Re: St. Lucie Units 1 and 2
Docket Nos. 50-335 and 50-389
Inservice Inspection Plans
Unit 1 Third and Unit 2 Second Ten-Year Intervals
Unit 1 Relief Request 21 and Unit 2 Relief Request 31
Request for Additional Information Response

**St. Lucie Units 1 and 2
Request For Additional Information Response
Inservice Inspection Program
Relief Request Nos. 21 and 31, Revision 2**

Figure 1-1: Crack Propagation Paths on the Finite Element Stress Model

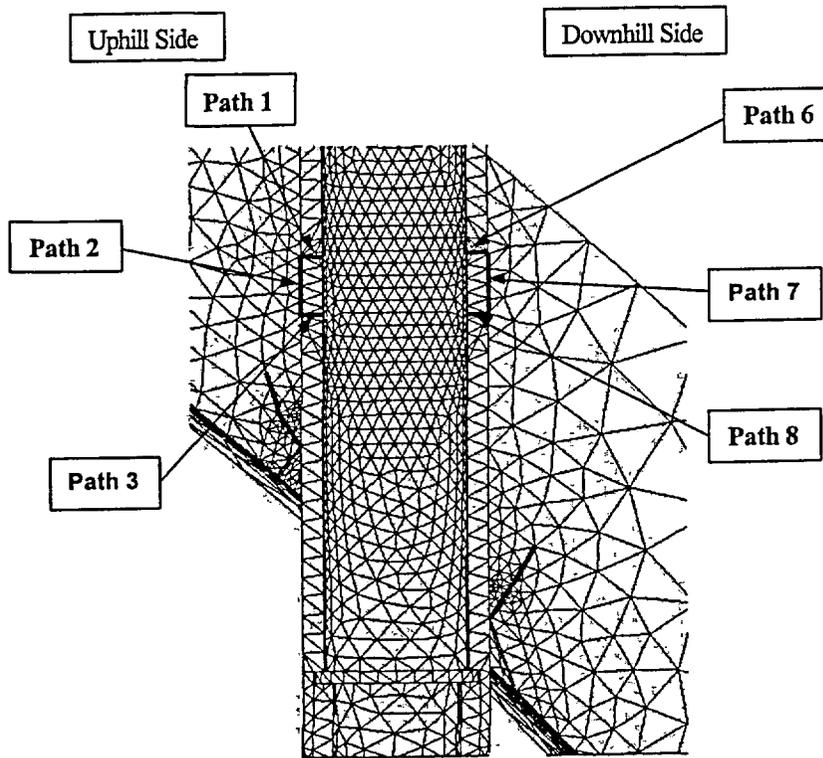
- b) An analysis of the new pressure boundary welds will be performed using a 3-dimensional model of a CEDM nozzle located at the most severe hillside orientation (Addressed in Calculations 1, 2, 4 and 5).

- g) Flaw evaluations will be performed for a postulated radial corner crack on the uphill side of the RPV head penetration, where stresses are the highest and radial distance from the inside corner to the low alloy steel base metal (crack depth) is the greatest (Addressed in Calculations 3 and 6)..

A fracture mechanics analysis was performed to evaluate a 0.100 inch semi-circular flaw extending 360 degrees around the circumference at the "triple point" location where the Alloy 600 (original nozzle), the Alloy 52 weld, and the low alloy steel head meet. The flaw is assumed to propagate in each of the two directions on the uphill and downhill sides of the nozzle. Flaw acceptance is based on the 1989 ASME Code Section XI criteria for applied stress intensity (IWB-3612) and limit load (IWB-3642). The results are summarized below and the flaw propagation paths are shown on Figure 1-1.

Initial flaw size	$a_i = 0.100$ in.
Maximum final flaw size	$a_f = 0.105$ in.
Maximum stress intensity factor	$K_I = 13.2$ ksi $\sqrt{\text{in}}$
Fracture toughness	$K_{Ia} = 200$ ksi $\sqrt{\text{in}}$
Fracture toughness margin	$K_{Ia}/K_I = 15.2 > \sqrt{10} = 3.16$

Bounding axial tube load	$P = 21,476$ lbs
Limit load	$P_O = 111,351$ lbs
Limit load margins	$P_O / P = 5.18 > 3.0$

Initial flaw size	$a_i = 0.100$ in.
Maximum final flaw size	$a_f = 0.106$ in.
Maximum stress intensity factor	$K_I = 15.0$ ksi $\sqrt{\text{in}}$
Fracture toughness	$K_{Ia} = 200$ ksi $\sqrt{\text{in}}$
Fracture toughness margin	$K_{Ia}/K_I = 13.3 > \sqrt{10} = 3.16$

Initial flaw size	$a_i = 0.100$ in.
Maximum final flaw size	$a_f = 0.107$ in.
Maximum stress intensity factor	$K_I = 12.6$ ksi $\sqrt{\text{in}}$
Fracture toughness	$K_{Ia} = 200$ ksi $\sqrt{\text{in}}$
Fracture toughness margin	$K_{Ia}/K_I = 15.9 > \sqrt{10} = 3.16$

Therefore, the ASME Section XI requirements were met.
